# **Gunnison County Environmental Health Board**

## **Agenda: March 21, 2019**

**GUNNISON COUNTY, COLORADO  
COMMUNITY DEVELOPMENT DEPARTMENT, ENVIRONMENTAL  
HEALTH OFFICE STAFF REPORT**

Application No: OWTS-18-00274  
 Date application scheduled with EH Board: March 21, 2019  
 Prepared by: Crystal Lambert, Building & EH Official

SP1

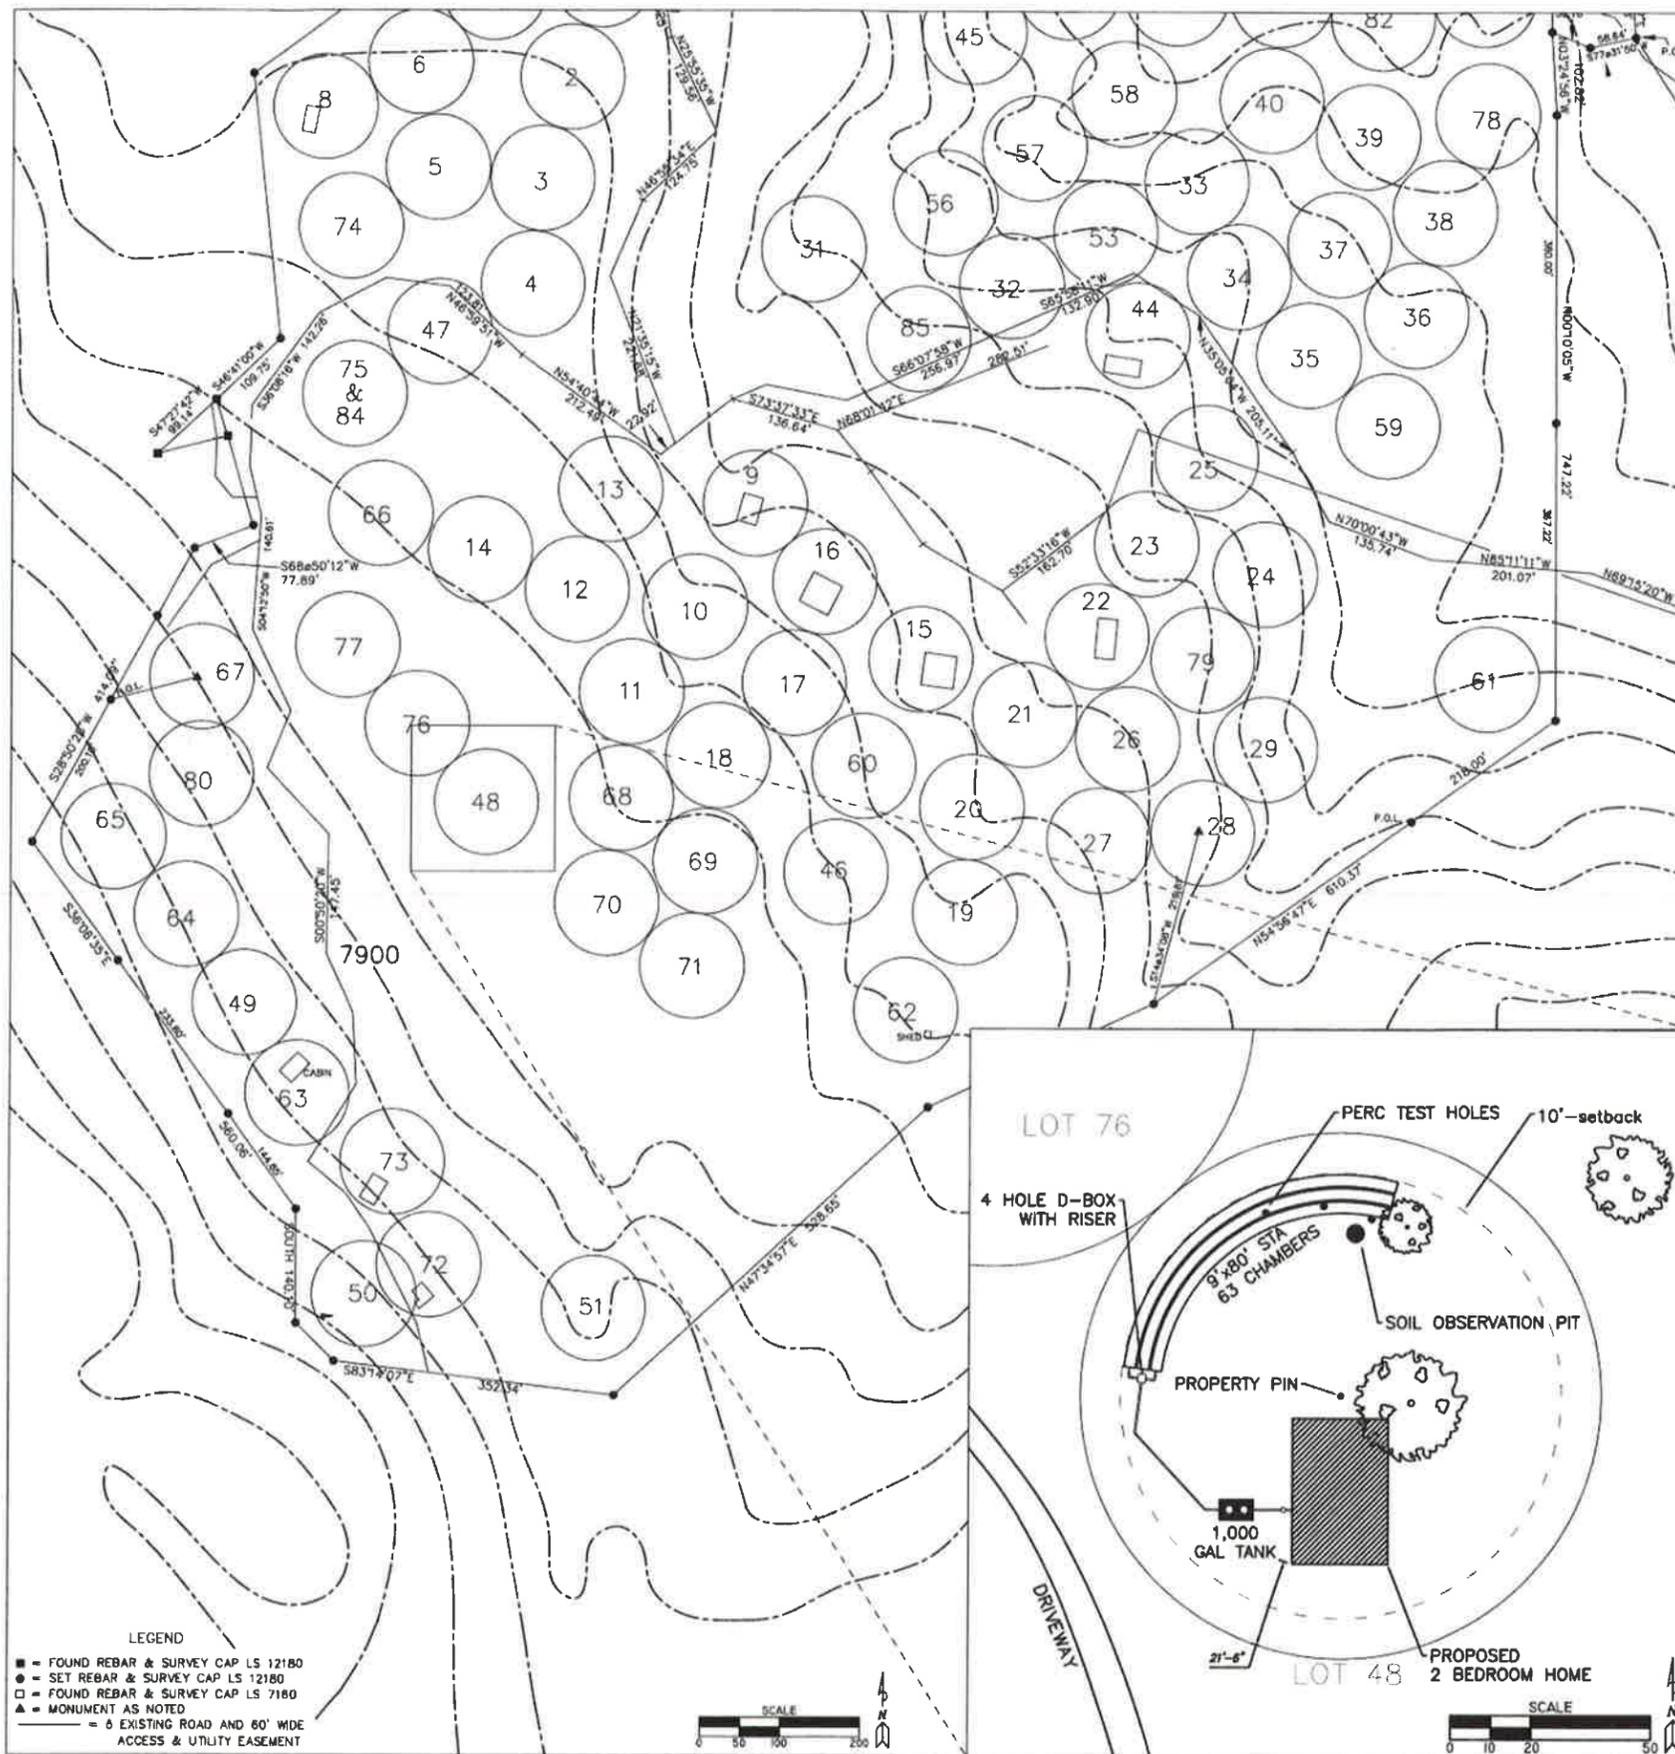
4. Prior to the issuance of the OWTS and building permits, a plan showing the location of the proposed water supply line to the structure and cistern location and size shall be submitted in order to verify that the proposed setback distance requirements and general construction standards are met.

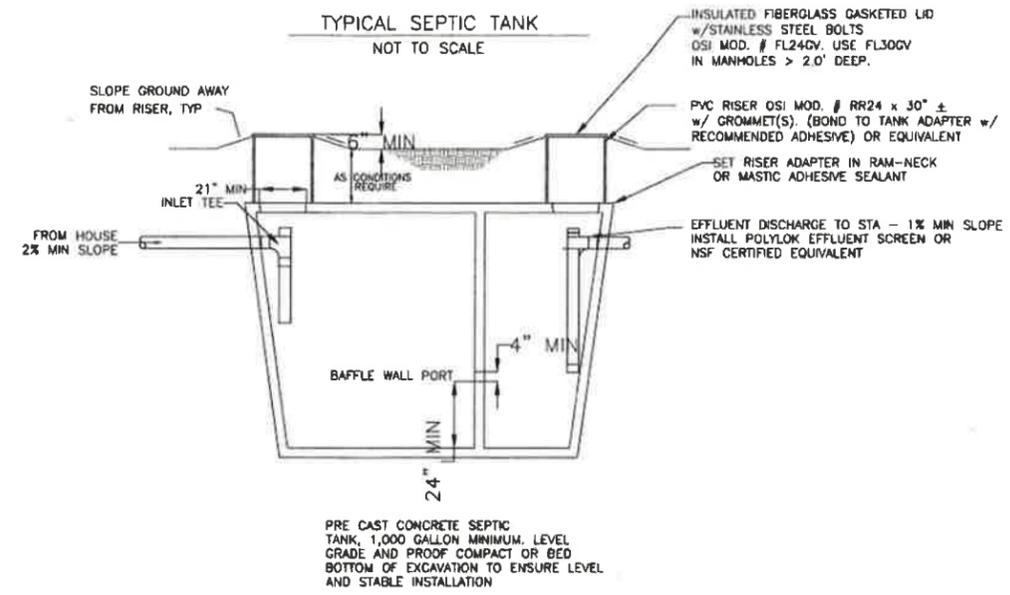
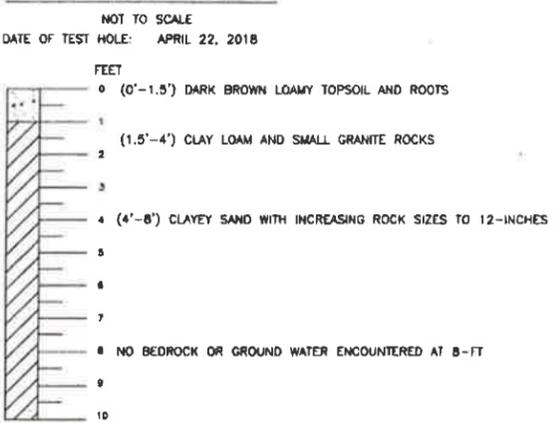
→ need visual & tactile evaluation as basis of design

Generally, except for the determination of the Long Term Acceptance Rate of the soil.

1. A visual and tactile evaluation of the soil in the vicinity of the soil treatment area, as required by *Section 5.D* of the *Gunnison County OWTS Regulations*, so that the Long Term Acceptance Rate of the soil can be confirmed for the system sizing and type.
2. An updated site plan that shows the location of the water supply lines and a cistern, if proposed, so that compliance with the minimum horizontal setback distances found in *Table 7-1* of the *Gunnison County OWTS Regulations* can be confirmed.
